APPLICATION NO.	FILING DATE	FIRST NAMED INVENTOR	ATTORNEY DOCKET NO.	CONFIRMATION NO.
10/083,060	02/26/2002	Kyle Spring	IR-1821 (2-2833)	4378

Office Action Summary	Application No.	Applicant(s)
	10/083,060	SPRING ET AL.
	Examiner	Art Unit
	Steven H. Rao	2814

DETAILED ACTION

Fig. 7I

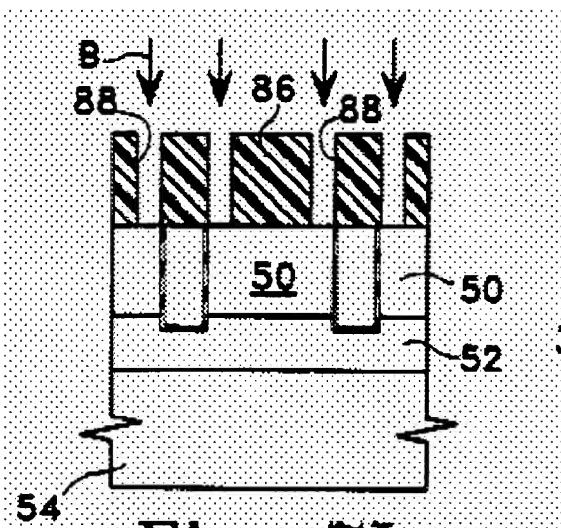
Further proof that Hshieh shows blanket implantation at least in figures 7 I and J and col. 7 lines 34-38 (reproduced below) which steps occur prior to forming other features of the device (see features formed in figures 7 L to 7 N) (are :

formed on the top of the structure. Boron is then ion-implanted into the masked structure with an implant dosage of approximately $3 \times 10^{14} \text{ cm}^{-2}$ to $1 \times 10^{15} \text{ cm}^{-2}$ under an implant potential of between 40 KeV to 100 KeV, as shown in FIG. 7I.
